Revision of Resolution No. 59 Guidelines for Waterway Signs and Marking

UNECE secretariat

Forty-ninth session of SC.3/WP.3
22 - 24 June 2016, Geneva

New signs

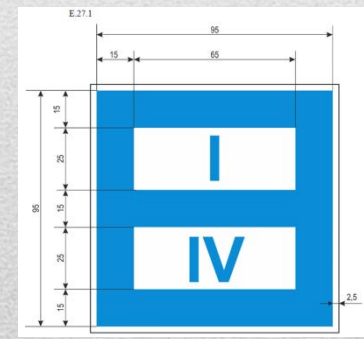
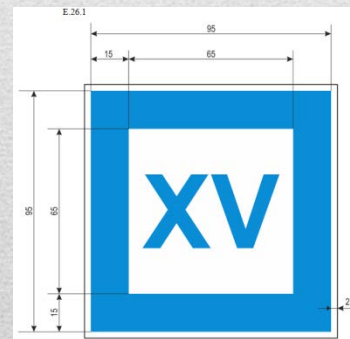
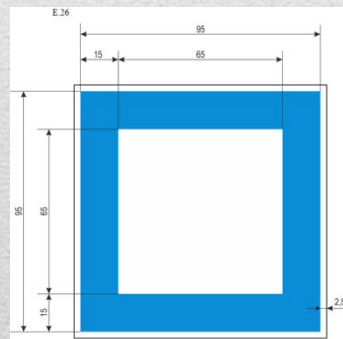
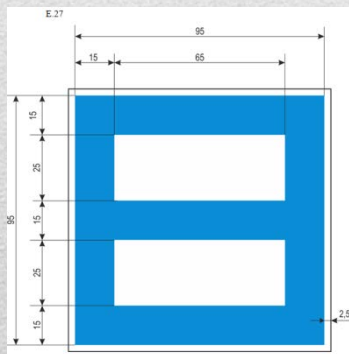
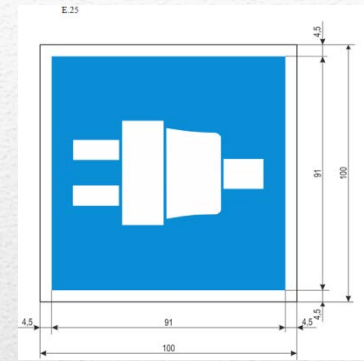
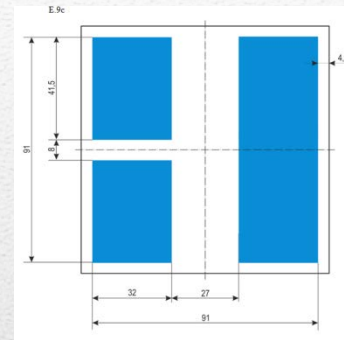
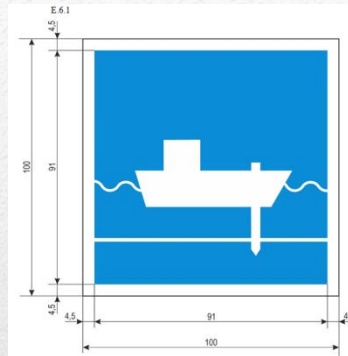
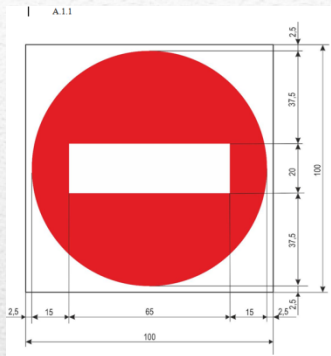
- **Floating signs:** Signs and signals installed on the waterway
- **Bank marks:** signs installed on the banks
- **Marking plan:** plan for the installation of signs and marks

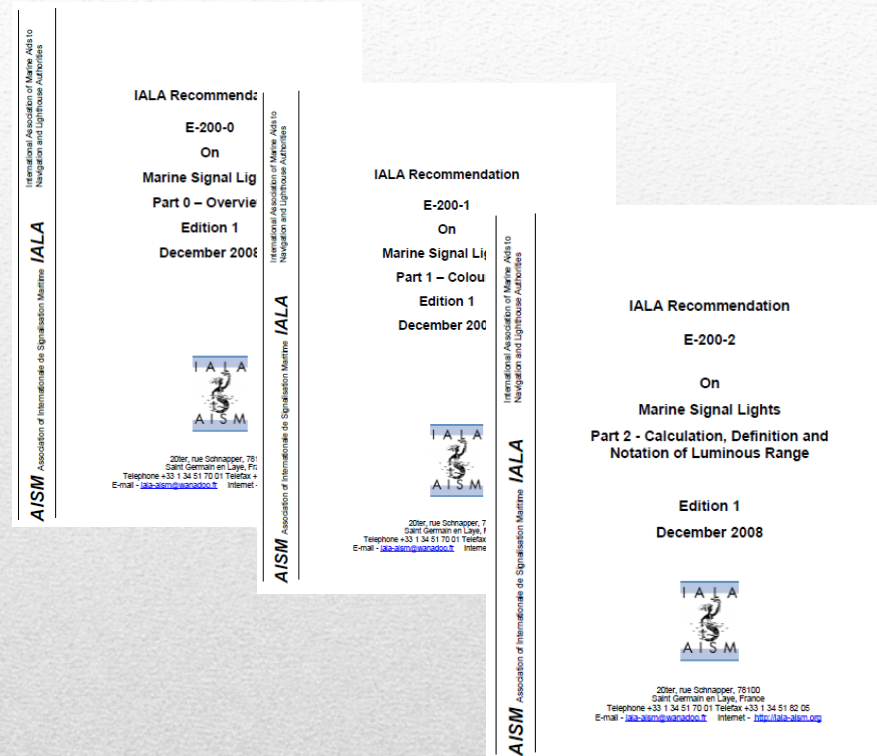
3.5 → In accordance with IALA recommendations, there are three degrees of visibility of signs and signals.

(a) → First: when, because of the distance, the sign is no more than a blotch on the background and neither shape nor colour can be distinguished (dotted outline); the sign is visible to the naked eye. The meaning of the sign is not yet identifiable (simply visible).

→ (b) → Second: when the sign is clearly visible and its shape and outline can be seen, but the colour remains unclear; identifiable according to CEVNI (identifiable).

(c) → Third: When the shape and colour of the sign can be seen distinctly, the sign is identifiable and distinguishable from its surrounding background (conspicuous).

→ Signs that must be seen by a boatmaster at some imperative distance ("no entry", "keep a particular sharp lookout", etc.) must have a visibility (due to their proper dimensions) of second or third degree. The type and dimensions of signs should be selected accordingly.

Third degree visibility is required when the sign or light is identifiable in principle, but cannot be easily seen at night owing to the surrounding background (presence of construction or a large number of light sources).

4.3 *Shallow water marking of shoals*

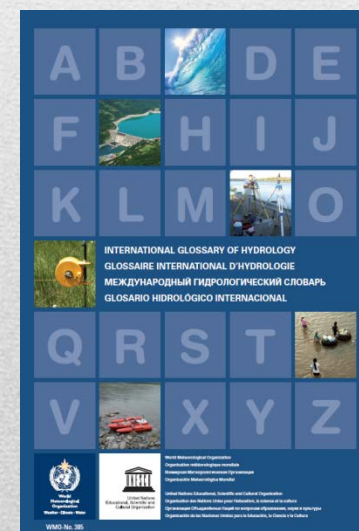
4.3.1 In ~~shallow water~~ **shoals**, as in other sections, **the principle of the continuous marking of the direction**⁷ ~~sets of marks ensuring a continuous marking of the fairway~~² shall be ~~installed~~ **applied**.

In ~~shallow water~~ **shoals** the fairway² can be marked by cross-channel fairway signs, bank marks² and **floating** signs ~~and signals on the water~~.

The term “shoal” is proposed instead of “shallow water” according to the International Glossary of Hydrology, World Meteorological Organization, Publication WMO-No. 385, 2012.

Appendix 1

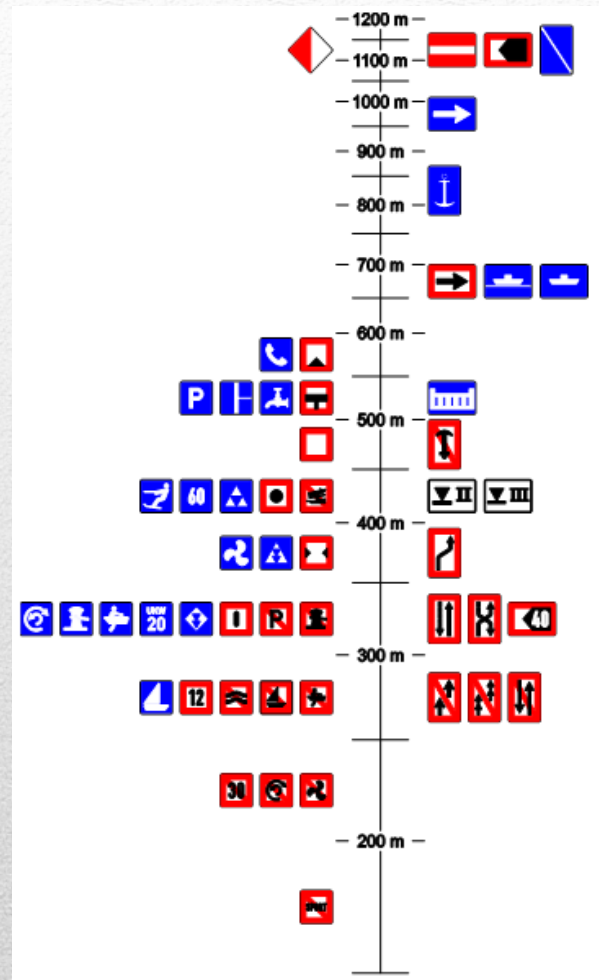
Guidance on the maximum distances at which the various signs are visible is given in the figure below. The distances are valid for boards with dimensions of 100 cm x 100 cm and 150 cm x 100 cm, with the observer positioned at a right angle to the surface of the board. When using boards of other dimensions, the distance at which the sign is visible should be recalculated according to the chosen scale.

For many types of European characters (e.g. ~~DIN 1451~~), when using black type on a white background, the maximum readability distance D – if the observer is positioned at a right angle to the surface of the board – is approximately $D \approx 465 h$, where h equals the height of the character (height of capital letters above the line).
